**MINUTES OF THE PROCEEDINGS OF THE PLANNING COMMISSION OF THE CITY OF STACY IN THE COUNTY OF CHISAGO IN THE STATE OF MINNESOTA PURSUANT TO DUE CALL AND NOTICE THEREOF**

**REGULAR MEETING  
MARCH 17, 2020, 7:00p.m.  
30955 FOREST BOULEVARD STACY MN**

## Memorandum

TO: **Stacy Planning Commission**  
FROM: Phil Carlson, AICP, Senior Planner, Stantec  
DATE: March 17, 2020  
RE: Kenneth Erickson – Interim Use Permit for Storage Containers  
Stacy Retail Center, 30962 Fenway Avenue, #300

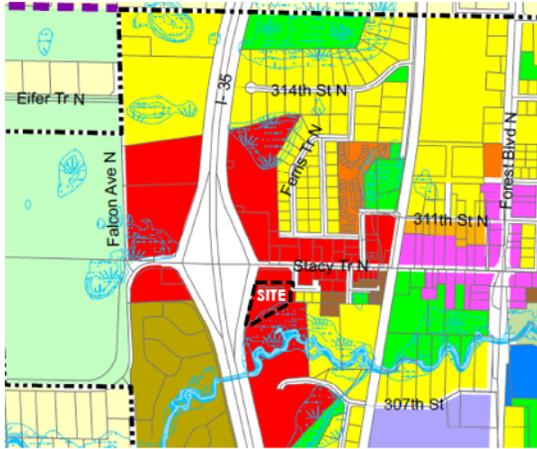
There was concern expressed at a previous Planning Commission meeting about the ground on which the containers would be placed and their structural support, as well as the potential impact on runoff and the river environment. The West Branch Sunrise River is about 350 feet south of the parking lot and proposed containers on the subject property. The City Shoreland Ordinance would apply to development with 300 feet of the ordinary high water level (OHWL) of the river, but only requires a 75-ft setback from the OHWL to structures. This project would not be close to these Shoreland setback requirements. Runoff to the river is an issue, however. City Engineer Dan Boyum provided the following comments:

- 1) Elevation information is not provided in the application. From review of the 2' contour information from the DNR, the area slopes to the south from the parking lot. The grading plan from the original development can be used by the applicant to provide some additional information on the elevation of the pad based on past comments from the Planning Commission.

- 2) Prior to work proceeding, silt fence or wood-chip biorolls should be placed to protect downstream areas. This protection can be removed once disturbed areas have been restored with grass. Cleaning of any silt that may build up against the silt fence or bioroll must be done until the area is established with grass.

- 3) No depth of rock is provided for in the application. Depending on the quality of the existing subgrade material in this area, the city's standard thickness for aggregate base is 6" to 8". We recommend that thickness be used for building a pad for the container.

- 4) It appears from the detail provided that the applicant wants to keep the containers level from the curb elevation to the south. Providing some of the elevation information noted above will help the applicant understand the slope in the area. We anticipate fill will be needed adjacent to the aggregate base as the pad heads to the south. The fill should be placed at a maintainable slope. The silt fence/biorolls discussed above should be placed south of any of this topsoil fill.

- 3) The placement of the containers will be reviewed by the City Engineer for adequate structural support, erosion control, stormwater handling, and other issues, to ensure there is no risk to health, safety, or the environment, in accordance with the following comments:

- a. Prior to work proceeding, silt fence or wood-chip biorolls should be placed to protect downstream areas. This protection can be removed once disturbed areas have been restored with grass. Cleaning of any silt that may build up against the silt fence or bioroll must be done until the area is established with grass.

- b. No depth of rock is provided for in the application. Depending on the quality of the existing subgrade material in this area, the city's standard thickness for aggregate base is 6" to 8". We recommend that thickness be used for building a pad for the container.

- c. It appears from the detail provided that the applicant wants to keep the containers level from the curb elevation to the south. Fill will be needed adjacent to the aggregate base as the pad heads to the south. The fill should be placed at a maintainable slope. The silt fence/biorolls discussed above should be placed south of any of this topsoil fill.

Portion of Tree Screening Plan & Views from I-35 Exist Ramp:

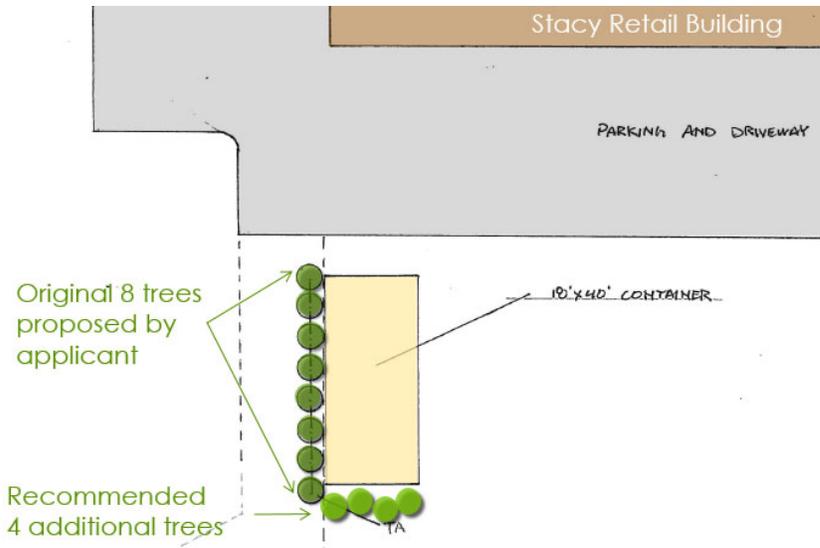
The proposed storage containers are "outside storage", only allowed in the GB District by CUP and only if fully screened so they will not be visible from adjacent properties. Being temporary, the containers also work well as an IUP, but the standards for a CUP can be appropriate to consider here. The proposed screening with a row of evergreen Arborvitae trees is a significant improvement compared to containers being in the open. As can be seen in the graphics on the next page, the proposed trees help, but the ends of the containers are still likely to be visible from the I-35 exit ramp. There are existing trees along the exit ramp, but they are tall and bare near the ground, providing little screening.

We suggest adding more trees to screen the south ends of the containers, which will help significantly with the view from the exit ramp. An additional 4 trees beyond the 8 trees proposed will accomplish this, as illustrated on the second page following.

Item 2: change the number of trees to twenty and the placement be on the East, West, and South sides of the containers. Additionally, the trees shall be six feet from the outside edge of the container to the inside edge of the screening. The trees shall be at least 6 feet tall.

- 1) The containers will be painted a color that is compatible with the existing Stacy Retail Center building.
- 2) Screening in the form of twelve Techny Arbovitae trees – the original eight trees plus an addition four trees – will be provided on the west and south sides of the containers as described and illustrated in this report.
